Re: St. Lucie Units 1 and 2 Docket Nos. 50-335 and 50-389 Proposed License Amendments GL 99-02 Charcoal Adsorber Test Protocol

Pursuant to 10 CFR 50.90, Florida Power & Light Company (FPL) requests to amend Facility Operating Licenses DPR-67 and NPF-16 for St. Lucie Unit 1 and Unit 2, respectively, by incorporating the attached Technical Specifications (TS) revisions. The amendments will revise the St. Lucie Unit 1 and 2 TS to require laboratory testing of activated charcoal samples for applicable engineered safety feature (ESF) ventilation systems using the ASTM D3803-1989 protocol.

# ST. LUCIE UNIT 1 MARKED-UP TECHNICAL SPECIFICATION PAGES

# ST. LUCIE UNIT 2 MARKED-UP TECHNICAL SPECIFICATION PAGES

3/4 7-21

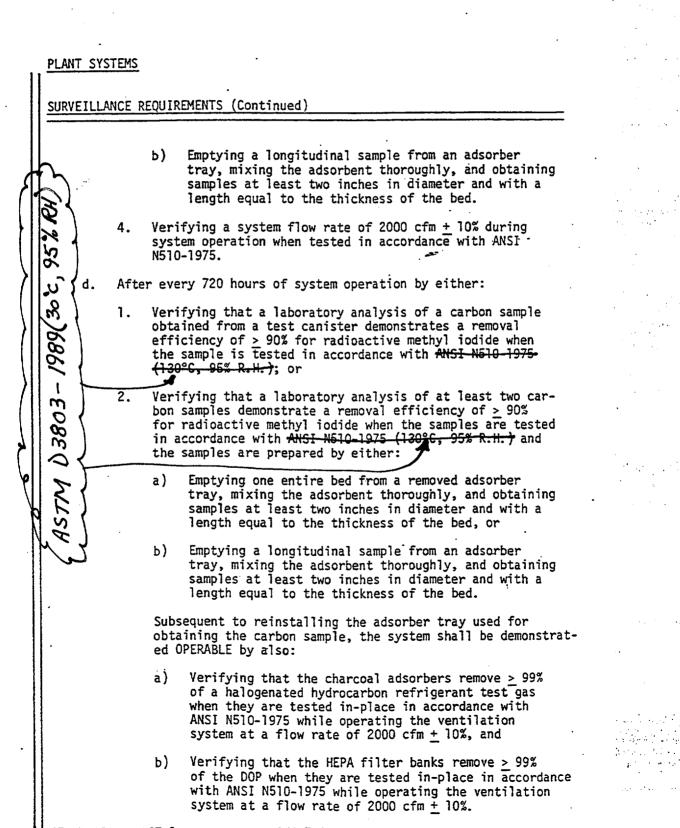
- B. St. Lucie Unit 1 Control Room Emergency Ventilation System:
- 1. Surveillance Requirement 4.7.7.1.c.3 Change ANSI N510-1975 (130°C, 95% R.H.) to ASTM D3803-1989 (30°C, 95% RH).

- 2. Surveillance Requirement 4.7.7.1.d.1 Change ANSI N510-1975 (130°C, 95% R.H.) to ASTM D3803-1989 (30°C, 95% RH).
- 3. Surveillance Requirement 4.7.7.1.d.2 Change ANSI N510-1975 (130°C, 95% R.H.) to ASTM D3803-1989 (30°C, 95% RH).
